Department of Planning & Development
Office of the Director

DATE: September 8, 2006
TO: Capitol Gateway Corridor BUILD Committee
FROM: Mark A. Olinger, Director
Department of Planning & Development
SUBJECT: Capitol Gateway Corridor BUILD Memo

Yahara River Birdseye Perspective: 8 story recommendation

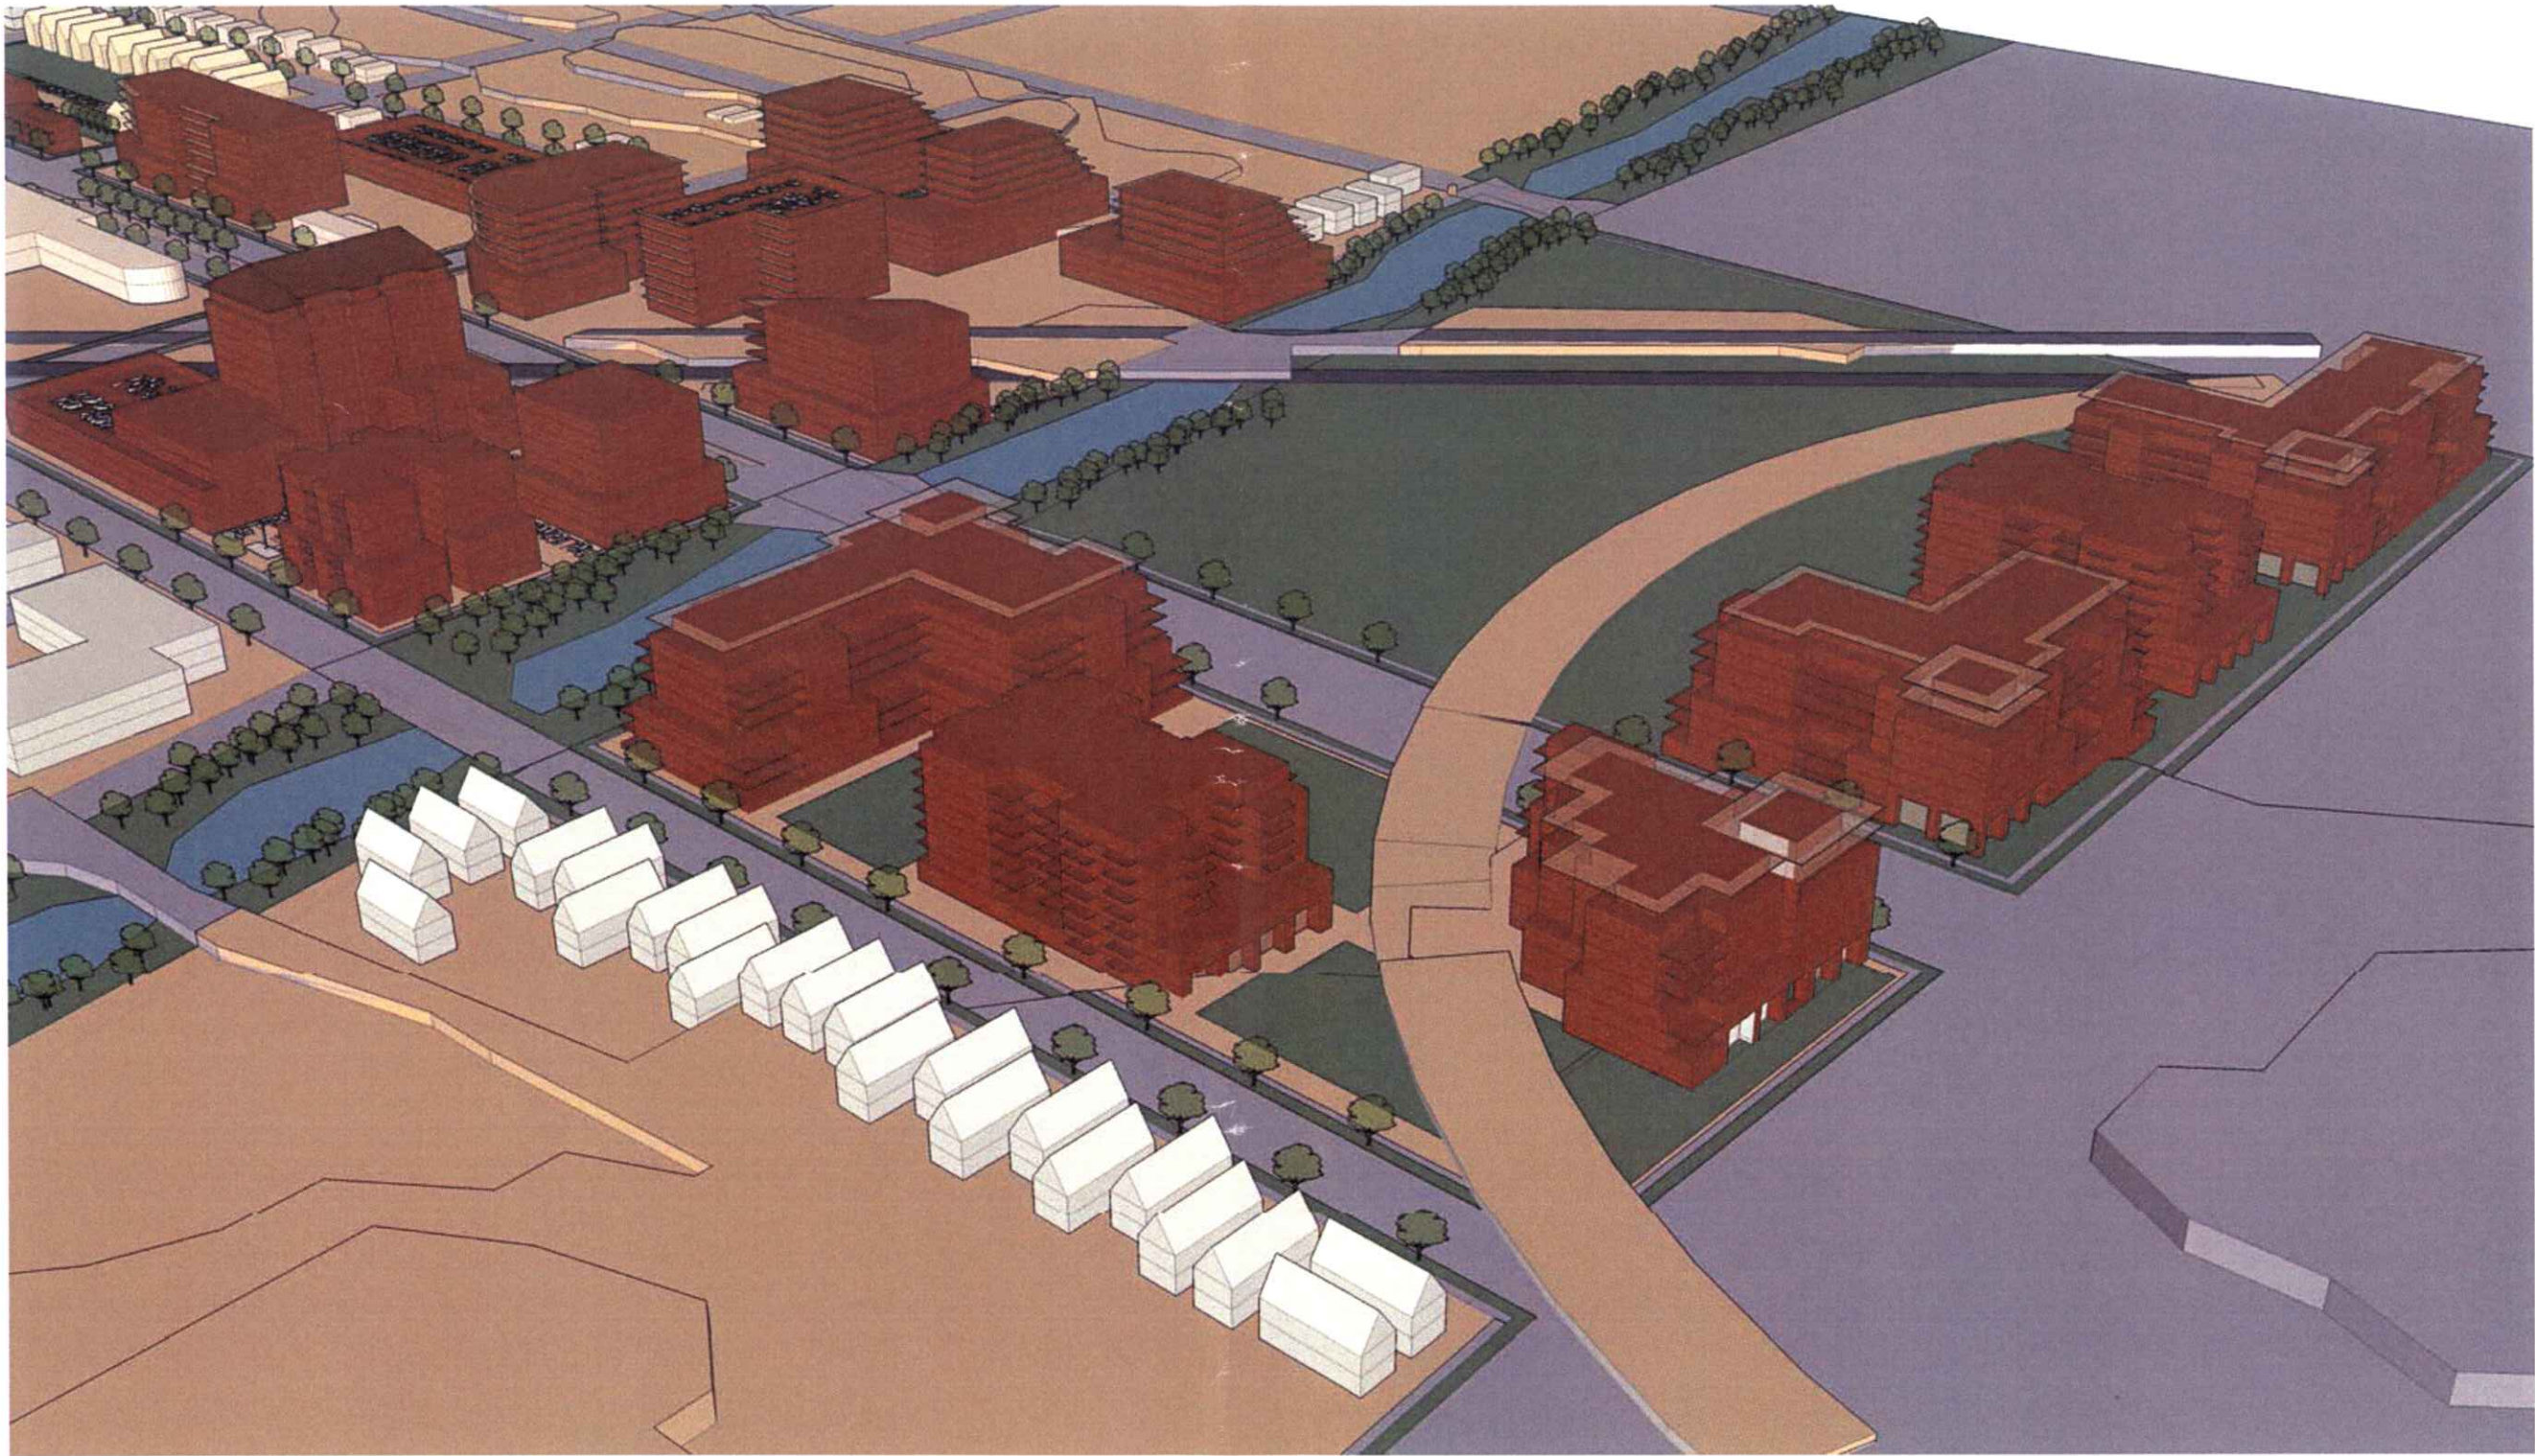
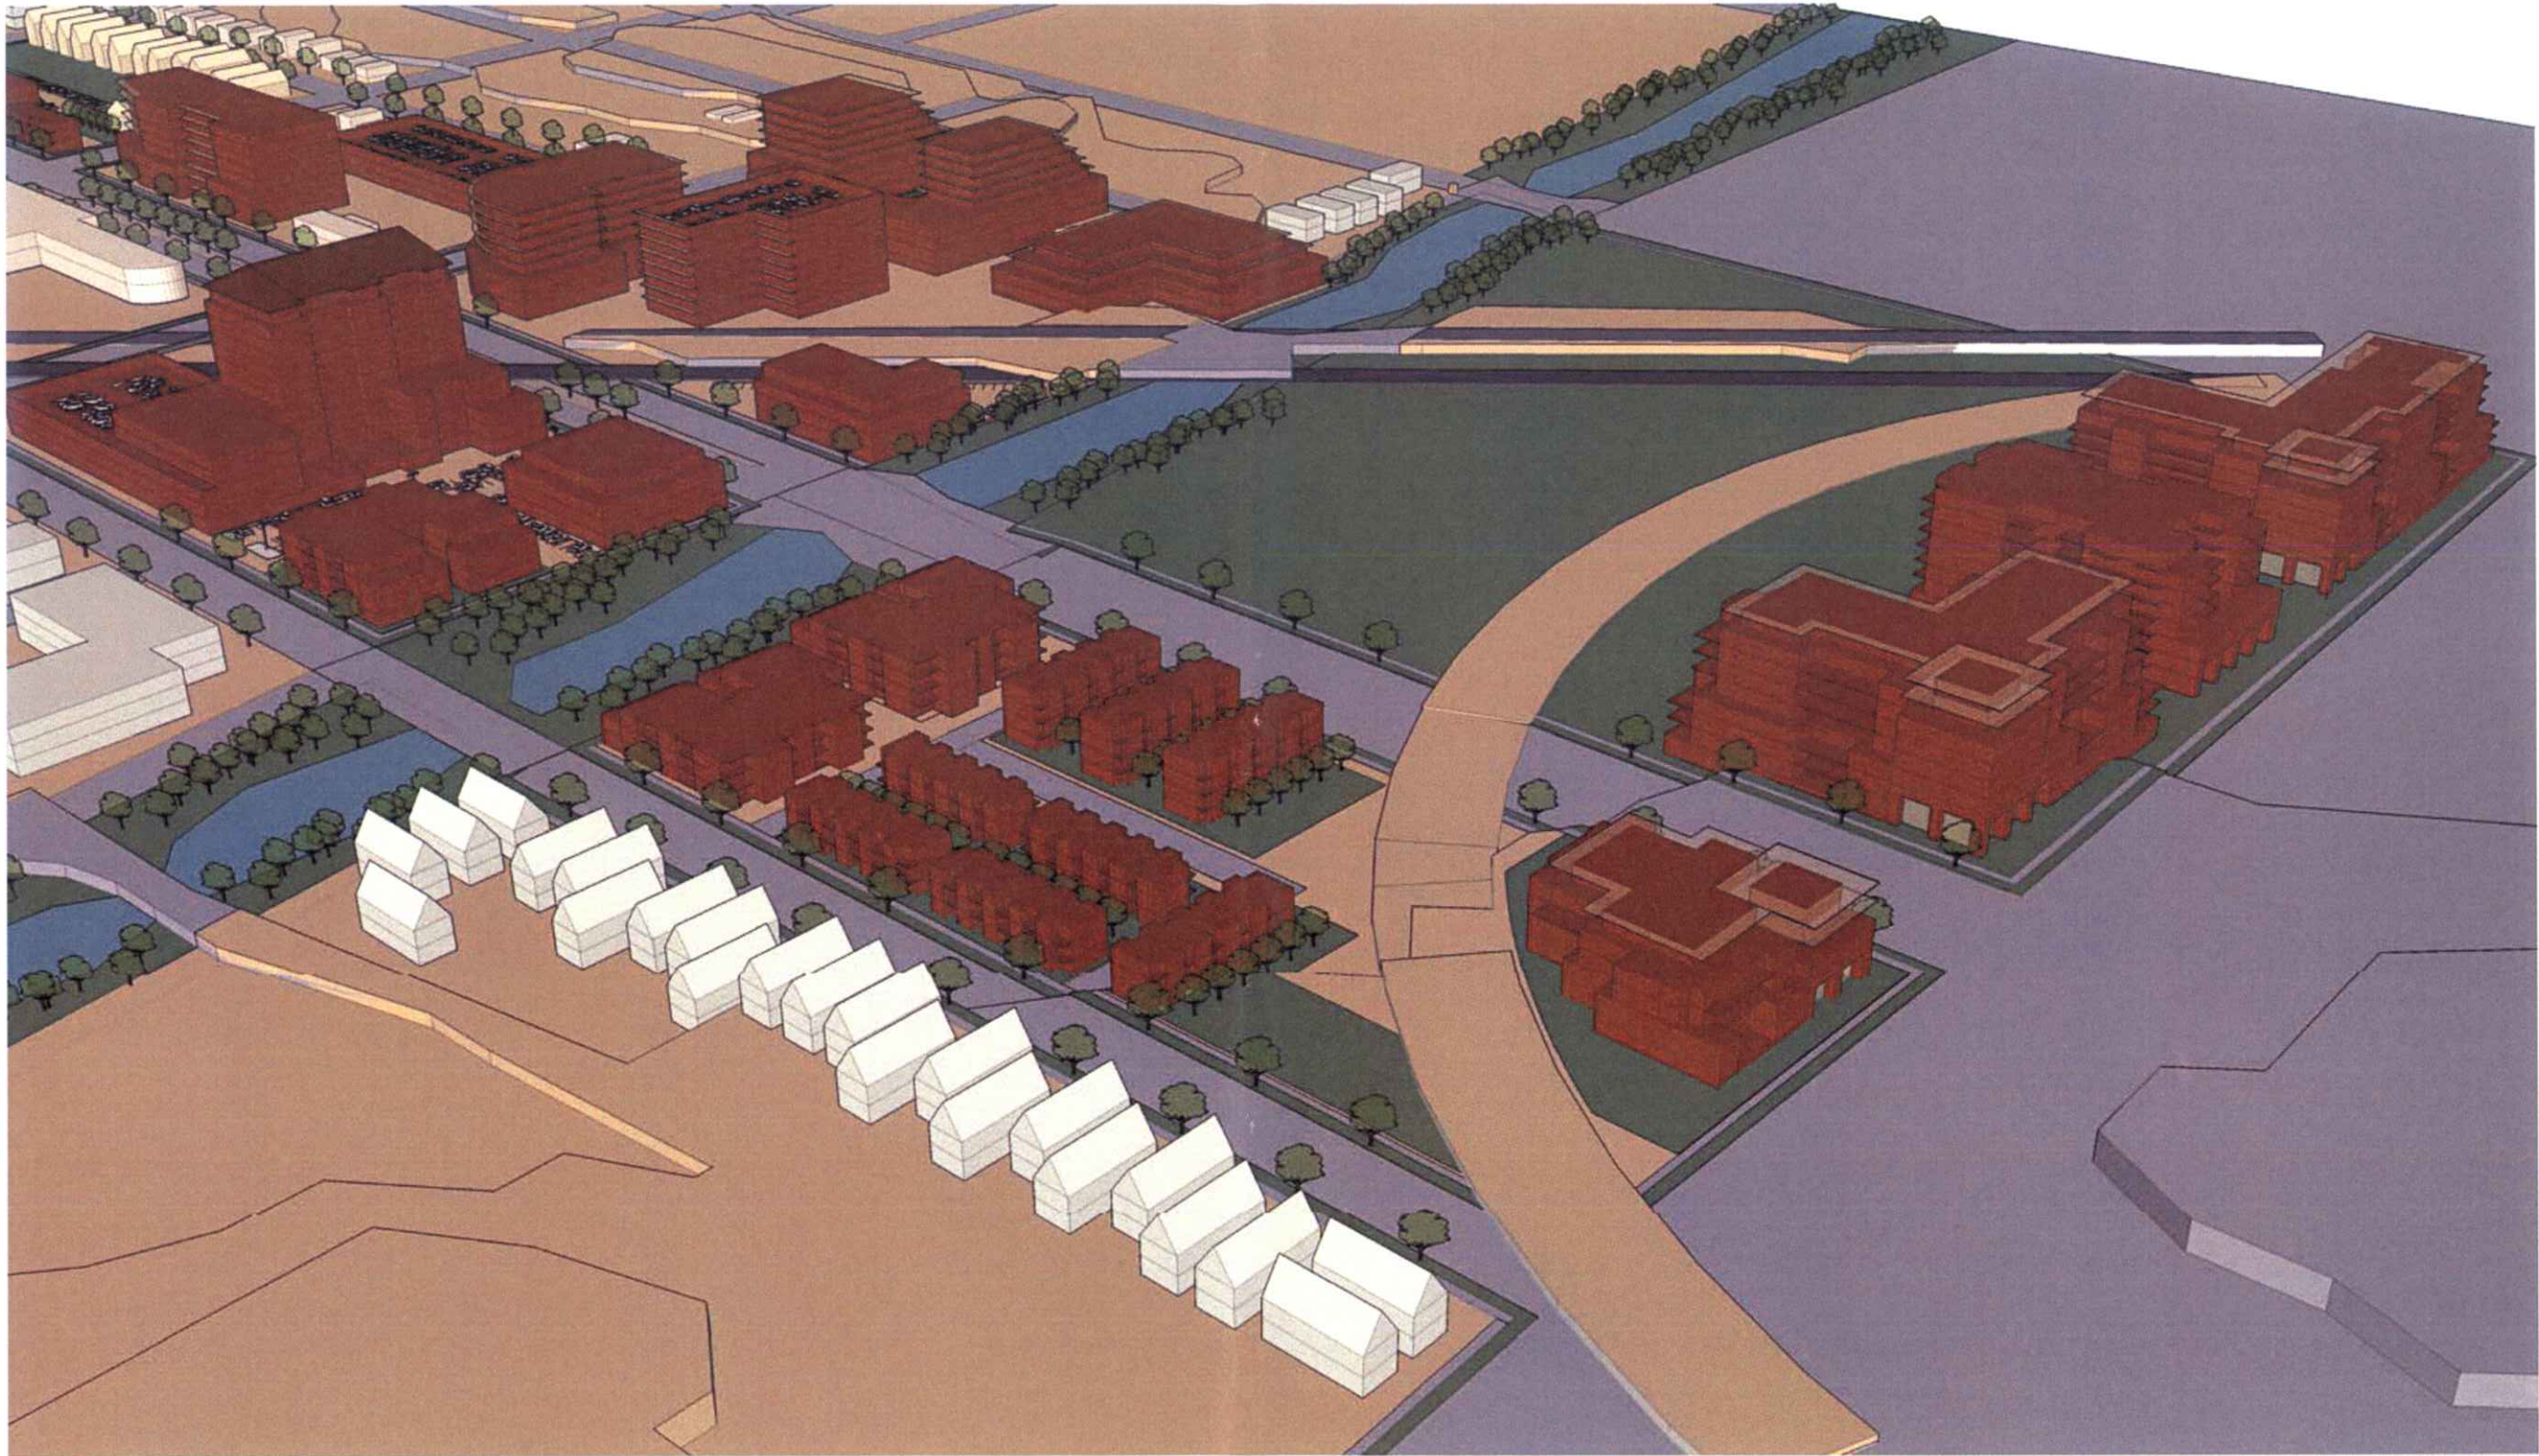
The intersection of East Washington and the Yahara River provides an interesting nexus of urban and natural resources. The challenge of that intersection is how we handle the interaction between these two resources. Department staff felt very strongly that development close to the river should be of smaller scale. That is why Blocks 8 and 17 had their boundaries adjusted – so that the scale would step down to the river. To show how that would look with the 3-4 story staff recommendation versus the 8-story draft recommendation, we have included a series of sketch-up massing studies for your review.
